To: Design Review Board
From: Scott Guter, AICP, Senior Planner
Date: September 3, 2019
File No.: DRV19-00306
Subject: **KIRKLAND URBAN SOUTH (PHASE 2) PROJECT
DESIGN RESPONSE CONFERENCE**

Kirkland Urban South

DESIGN RESPONSE CONFERENCE #3:
9/4/2019

Enlarged West Elevation

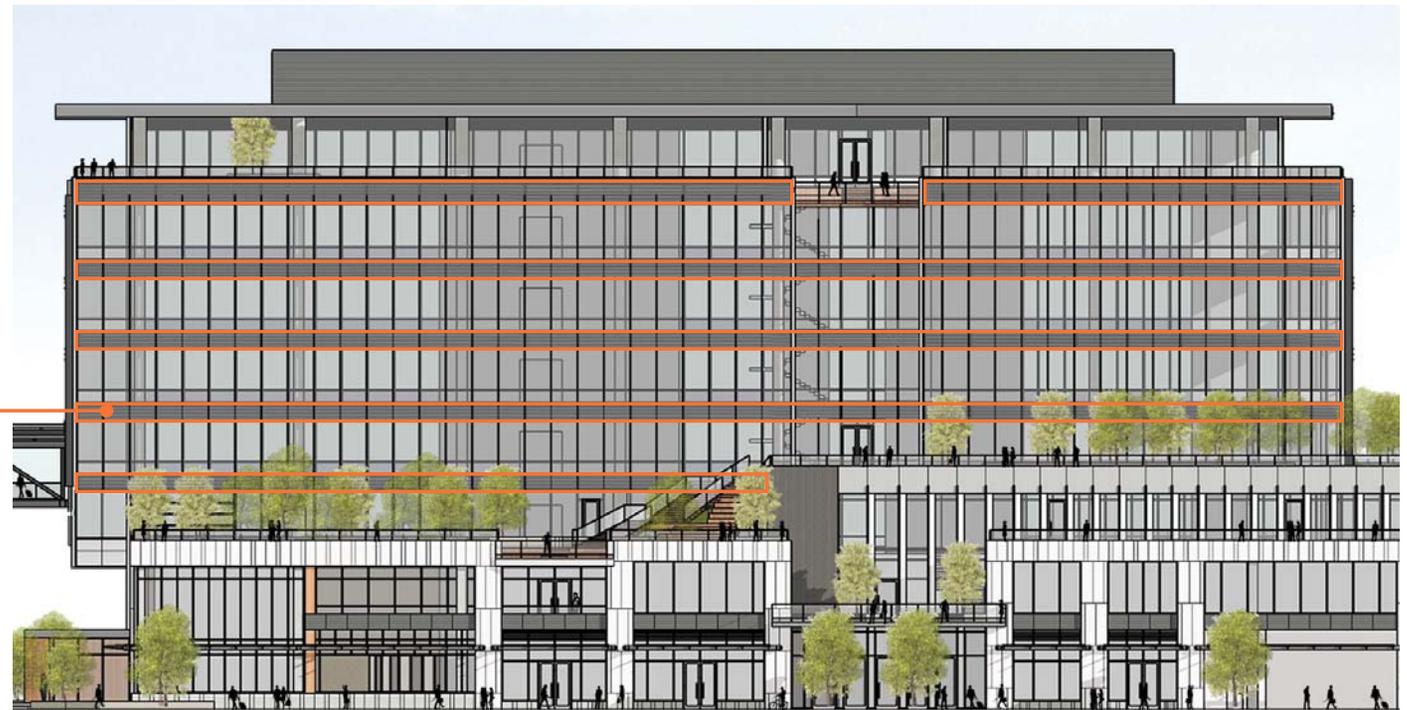
- 1. West Facade Glare
 - Investigate methods of reducing glare on the west facade, including adding shading devices and reducing the use of reflective coatings.

Vertical fin spacing has been decreased to 5' on center to increase the area of glass being shaded throughout the day, which should mitigate glare.

In addition, the low-e coating can be removed in areas of the facade with spandrel glass, which will allow the glass to be less reflective and cast less of a glare.

Enlarged East Elevation

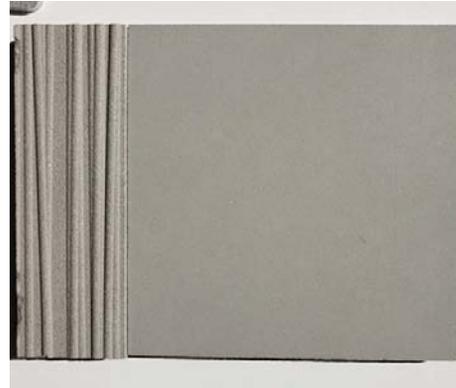
3. East Facade Blank Wall
- Clearly identify materials to be used.
 - Break up the scale of the upper wall with joints or other architectural elements

High performance concrete panels in artictic pattern

Architectural canopies break the lower wall into a pedestrian scale

Exposing the columns creates a rhythm that echoes the floors above

Overhanging the upper mass of the wall splits the surface in half horizontally

4. Skybridge Design & Location

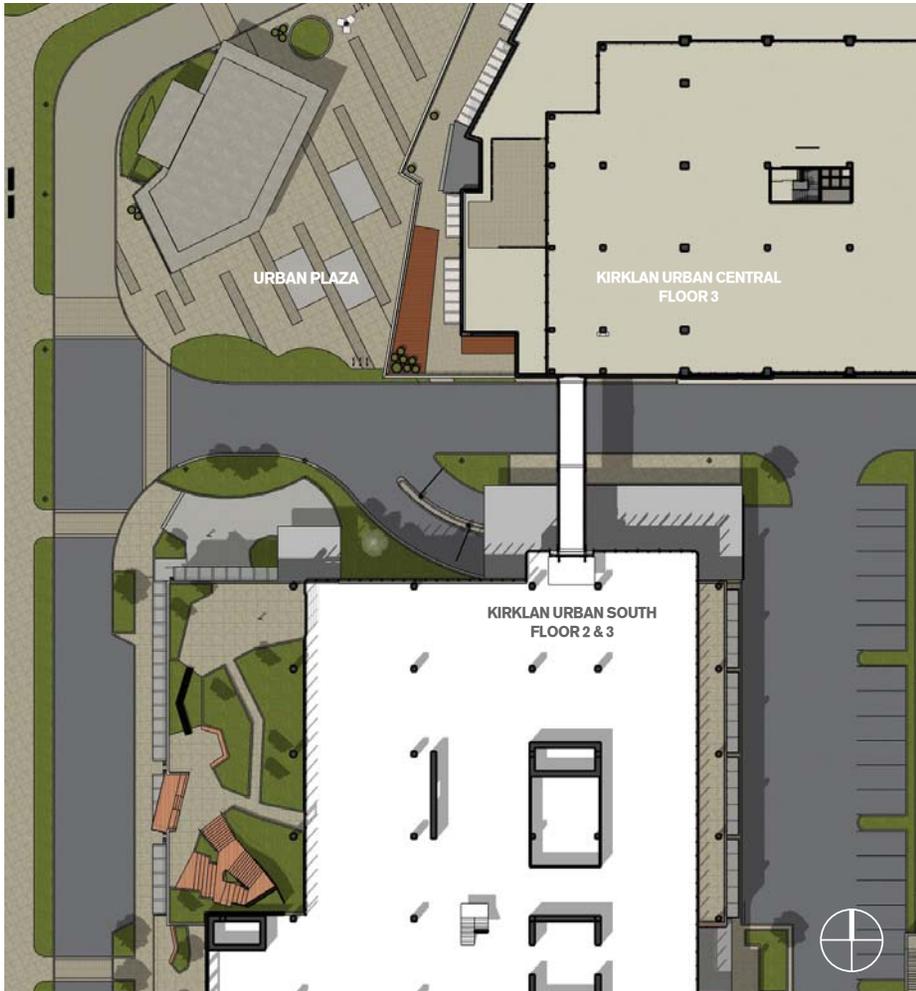
- Investigate moving skybridge to make it less visible from public spaces.
- OR design the bridge to be a sculptural element in its current location.

The skybridge has been moved back away from the park edge and public plaza, significantly reducing its span between the buildings. The design has been kept modest, blending in with the existing buildings.

Thought has been given to how it intersects each building on the ends, lining up with existing material lines on the Central building, and landing in a small notch on the South building.
